## **Addendum # 5**

**Dated: September 27, 2024**

### **Bid Opportunity: T-24-33 - General Contractor for the Construction of a Helicopter Hangar and Related Interior and Exterior Spaces in the Town of East Gwillimbury, Ontario**

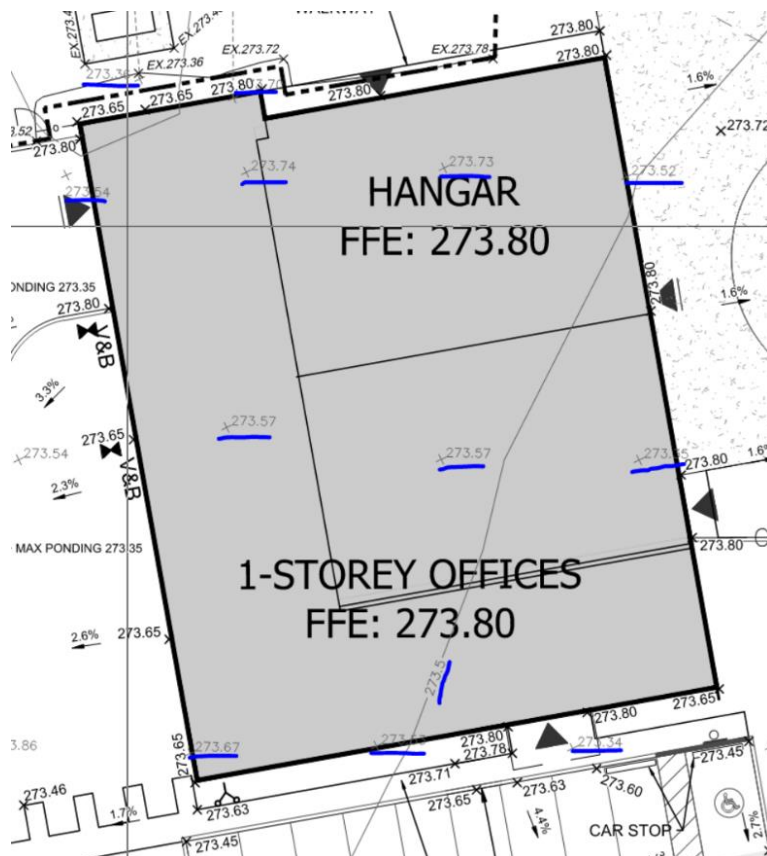
Drawing C-201 (Site Grading Plan) does not show the existing ground levels beneath the hangar and 1-story offices. This information is critical for calculating accurate earthwork pricing. Please provide the existing ground levels for these areas.

**Answer 158: Existing grades are included on the site grading plan as highlighted below. An existing topo only drawing has been included as part of this Addendum for reference and to clarify current elevations**

MAY-16-24 - CURRENT  
TOPOGRAPHICAL PLAN

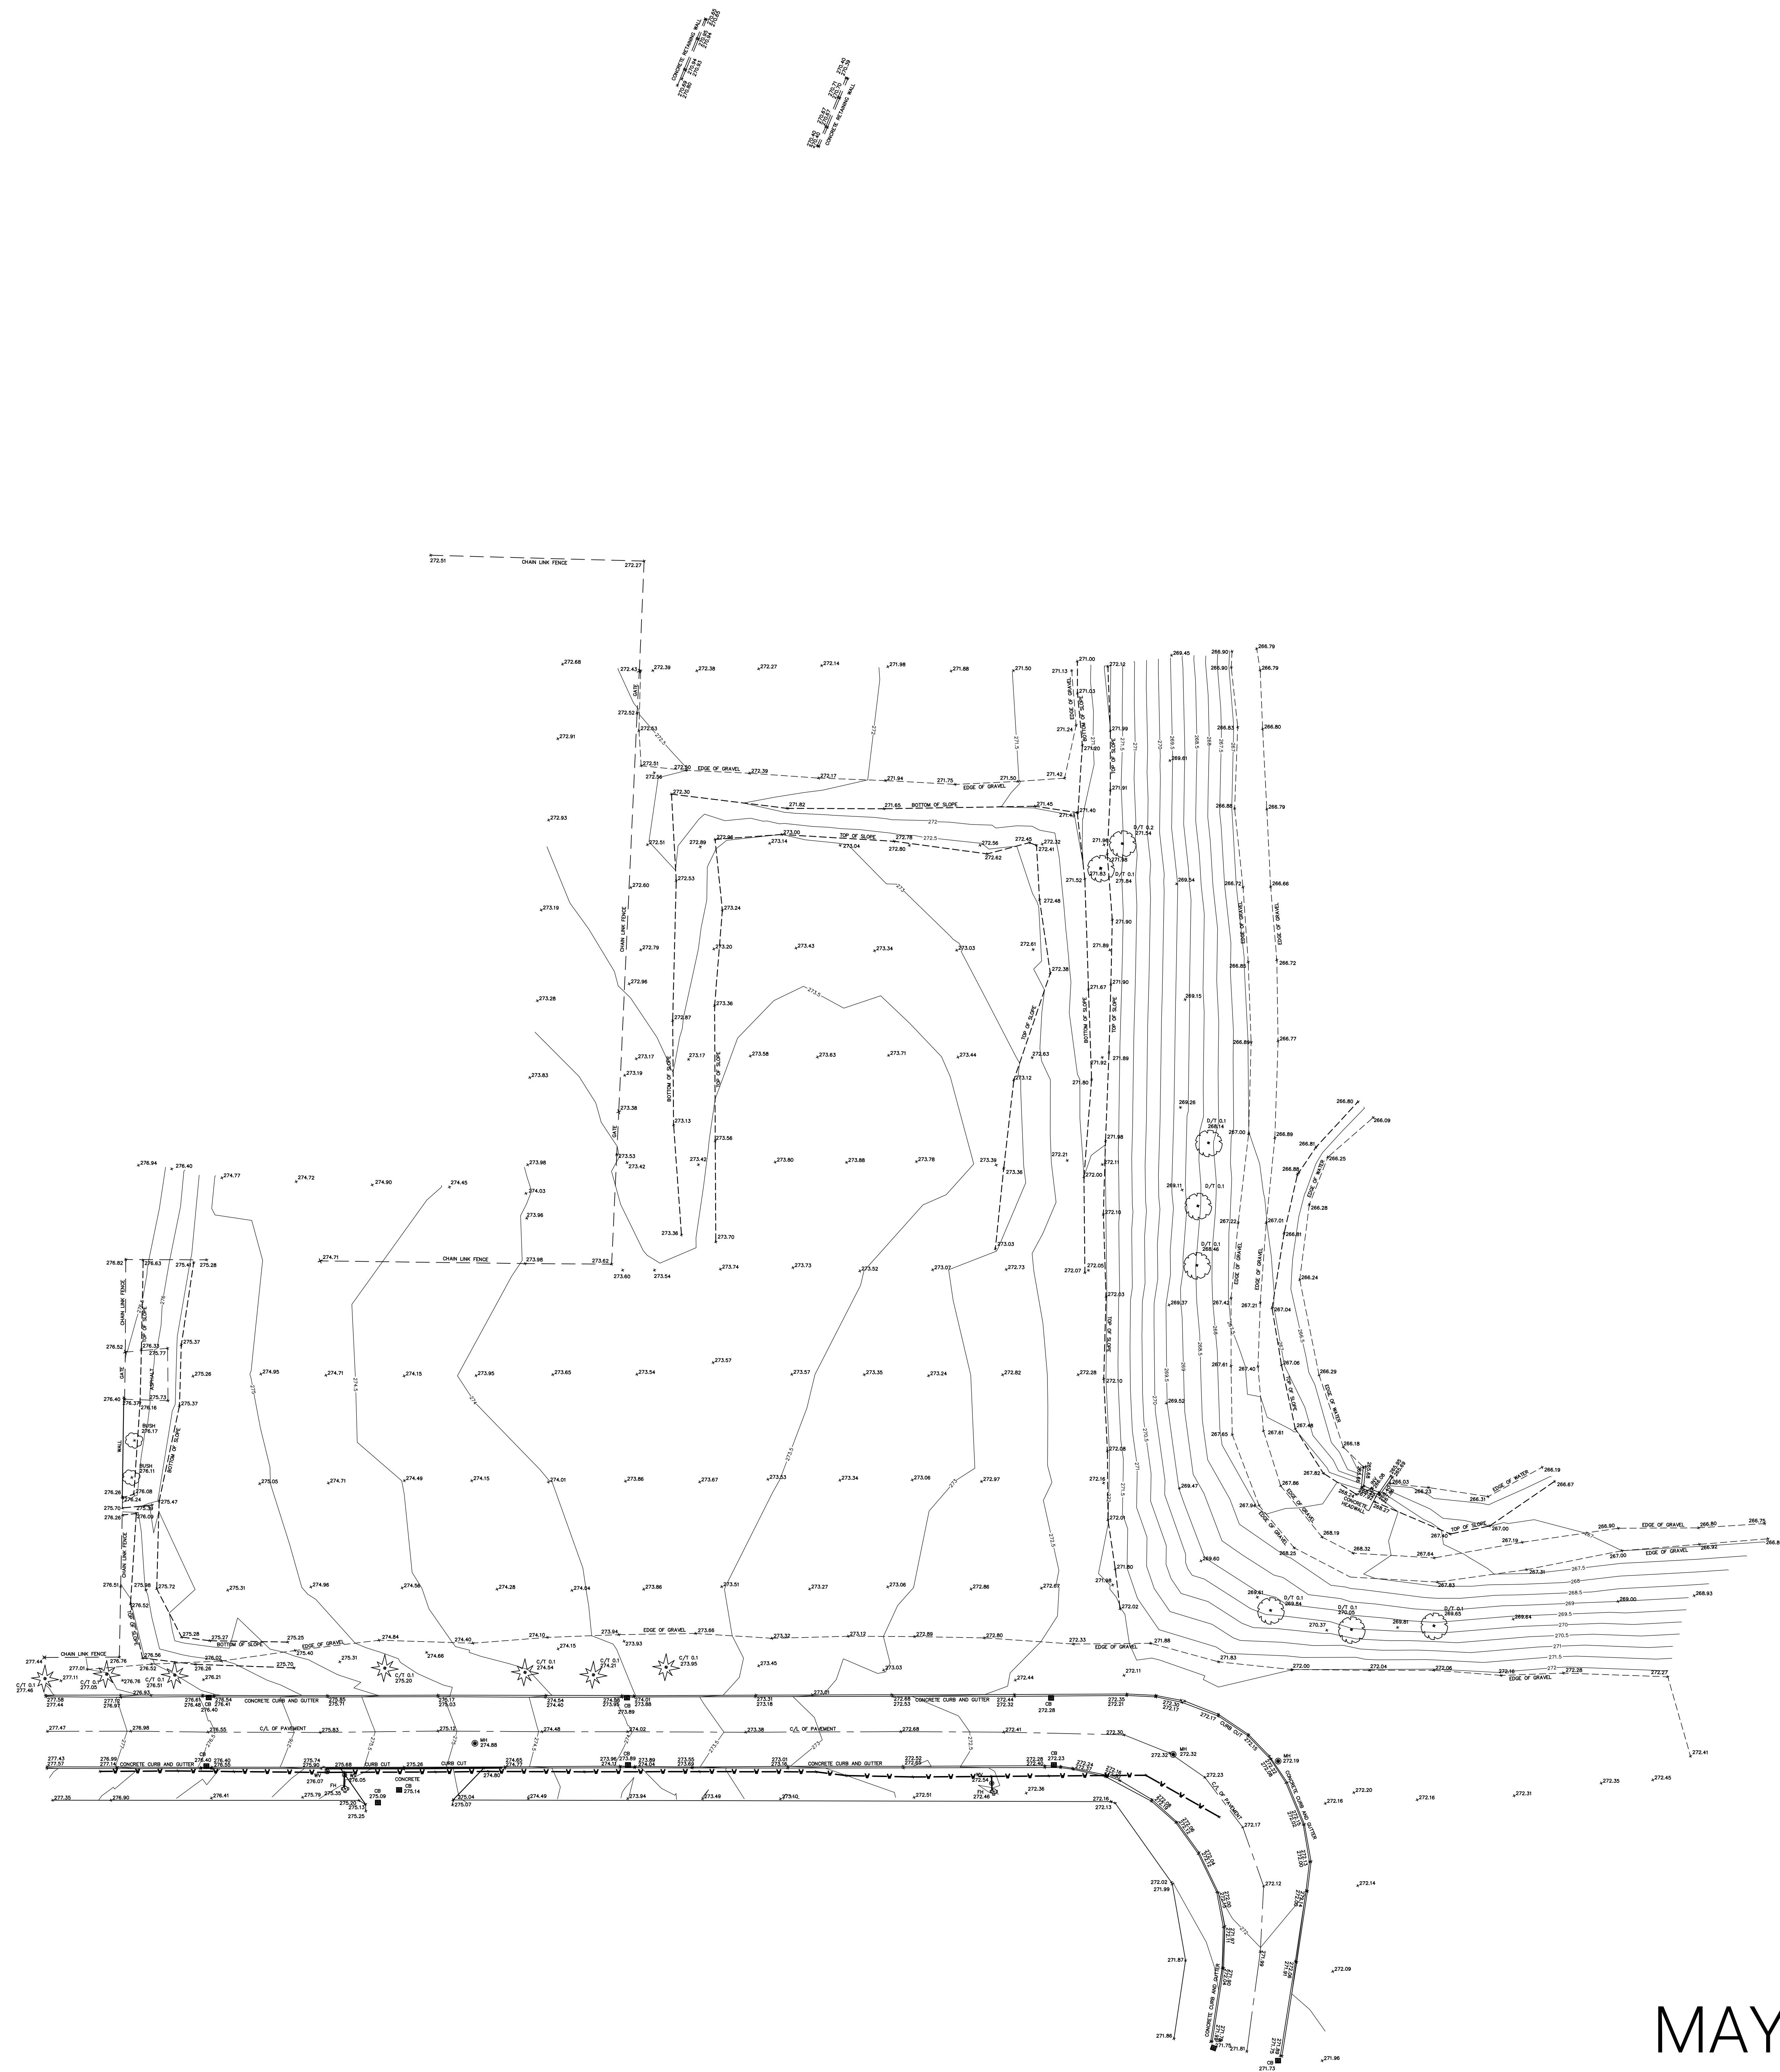
Upon reviewing Drawing A-001, it appears that there are two different sets of numbers indicating the existing ground level. Could you please confirm which set of numbers should be considered as the accurate existing ground level for this project?

**May -16-24 – Current Topographical Plan drawing included for reference and clarity**

**Answer 157: refer answer 158 below for clarification of current elevations**
